**LEE'S SUMMIT**  
MISSOURI  
Development Services Department

## Development Services Staff Report

<b>File Number</b>	PL2022-079
<b>File Name</b>	REZONING from AG to CP-2 and PRELIMINARY DEVELOPMENT PLAN – Whataburger
<b>Applicant</b>	Whatabrands, Inc
<b>Property Address</b>	204 SW M-150 Hwy
<b>Planning Commission Date</b>	April 28, 2022
<b>Heard by</b>	Planning Commission and City Council
<b>Analyst</b>	C. Shannon McGuire, Planner
<b>Checked By</b>	Hector Soto, Jr., AICP, Senior Planner Kent Monter, PE, Development Engineering Manager

### M-150 CDO design standards

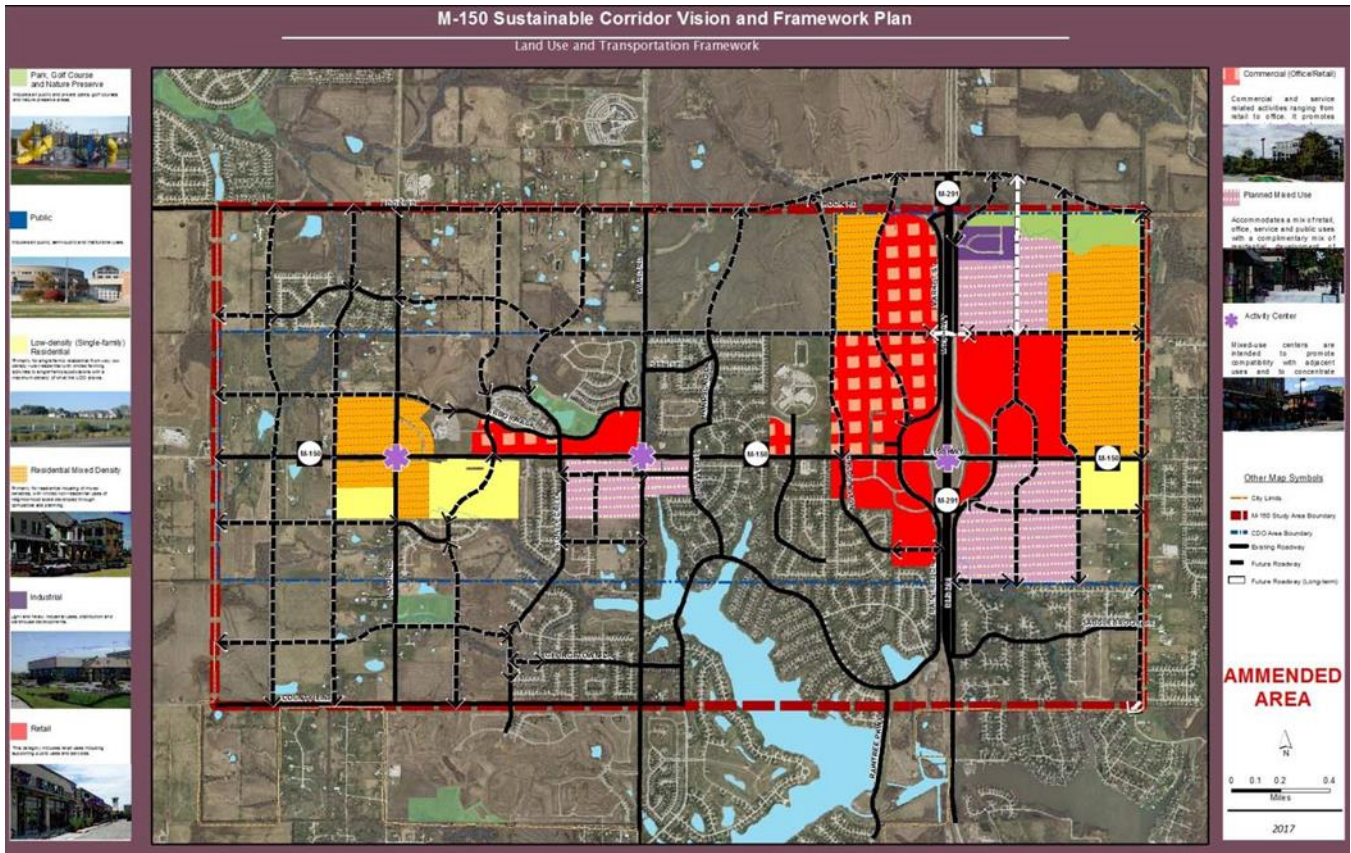
The subject property is located within the boundaries of the M-150 Corridor Development Overlay (CDO) District. In an effort to promote sustainable development within the M-150 Corridor, the overlay district encourages the integration of water and energy conservation techniques in site planning and building design by establishing minimum sustainability requirements. To address these requirements, the developer has proposed to incorporate the following features:

- Cool roof
- Drip irrigation systems for landscaped areas
- Materials that are produced from renewable resources
- Shaded walkways

The developer has further addressed overlay district design requirements by adding landscape screening around the proposed transformer location. In addition to the required public sidewalk along SW Summitcrest Dr., the CDO requires a network of on-site pedestrian walkways with a minimum width of five (5) feet to and between public sidewalks along the perimeter streets adjacent to the development. The applicant has met this requirement by proposing a five (5) foot sidewalk that will provide the required connection between the private and public sidewalks.

The M-150 CDO requires that all roof-mounted mechanical equipment be screened by a parapet wall or similar feature that is an integral part of the building's architectural design. The applicant proposes to meet

the CDO design standard by providing a parapet wall of a height equal to or greater than the height of the mechanical equipment being screened.
